Site Survey of Selected Items
for
Compliance with the Americans with Disabilities Act
(ADAAG)
and
Title 24 of the CBC

The site survey of Peary Middle School was conducted on November 30, 2006 during a spot check for compliance with the Americans with Disabilities Act Guidelines (ADAAG) and Title 24 of the CBC

Facility Name: Robert Peary Middle School

Boys Restroom Across from Room 33 Admin. Building

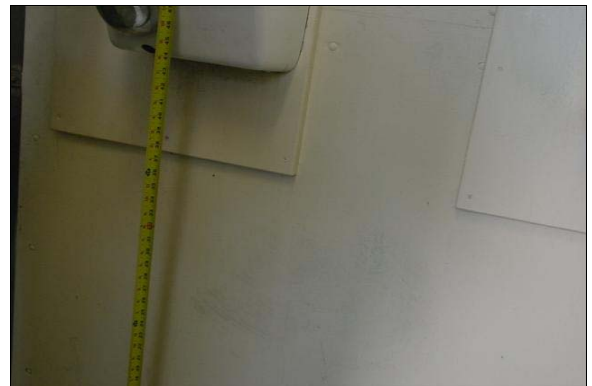
Finding: The height of the controls and operating mechanisms for the hand dryer is greater than 40 inches in height.

Full Rec Relocate the hand dryer to a maximum height of 40 inches for all the controls and operating mechanisms (see CBC 1115B.9.2).

Staff Mens Restroom First Floor Administration Building

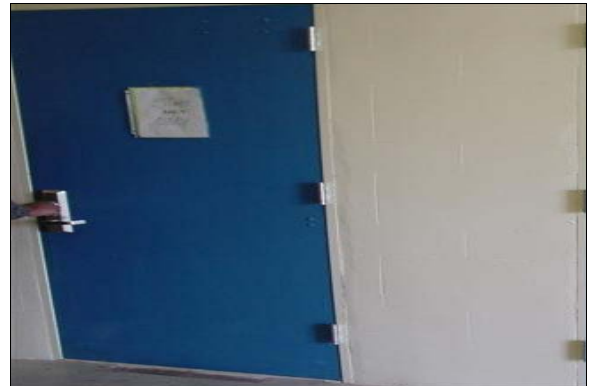
Finding: There is no signage indicating accessibility on the latch side of the entry door of the restroom. There is no Title 24 gender use signage on the entrance door.

Full Rec Post signage centered 60 inches above the ground surface on the latch side of the entrance door identifying the restroom as accessible. Signage shall include Braille and raised lettering, the gender or unisex use symbol and the ISA symbol. Post Title 24 gender use signage on the door @ 60" o.c. a.f.f.

Staff Unisex Restroom Second Floor Administration Building

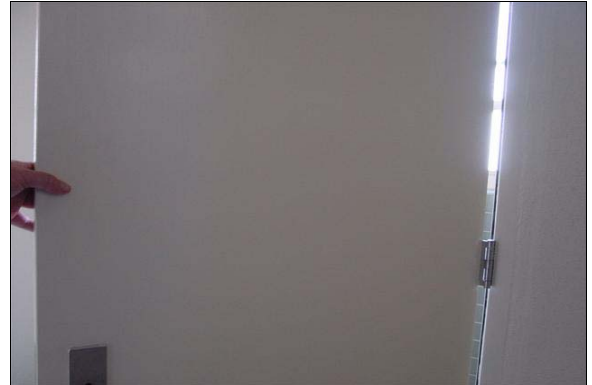
Finding: There is less than 12 inches of clearance on the latch side of the hallway entrance door that leads to the staff unisex restroom, from the push side.

Full Rec Provide at least 12 inches of latch side clearance at the entrance door to the restroom from the push side (see ADAAG 4.13.6 and Figure 25). Otherwise, install an automatic door opening device to the primary entrance complying with ADAAG 4.13.12 and ANSI/BHMA A156.10, 1985, standards.

Student Unisex Restroom in Room 52 Home Ec. Bldg

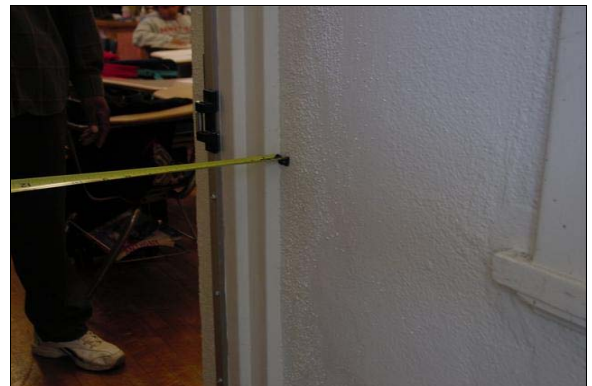
Finding: There is less than 12 inches of clearance on the latch side of the entrance door to the restroom from the push side.

Full Rec Provide at least 12 inches of latch side clearance at the entrance door to the restroom from the push side (see ADAAG 4.13.6 and Figure 25). Otherwise, install an automatic door opening device to the primary entrance complying with ADAAG 4.13.12 and ANSI/BHMA A156.10, 1985, standards.

Unisex Restroom in Shop Building Room 61

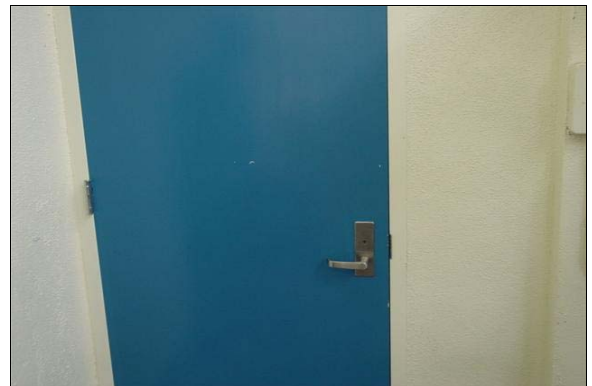
Finding: There is no accessible lock on the unisex restroom door.

Full Rec Provide accessible locking door hardware that displays the word OCCUPIED on the unisex restroom door.
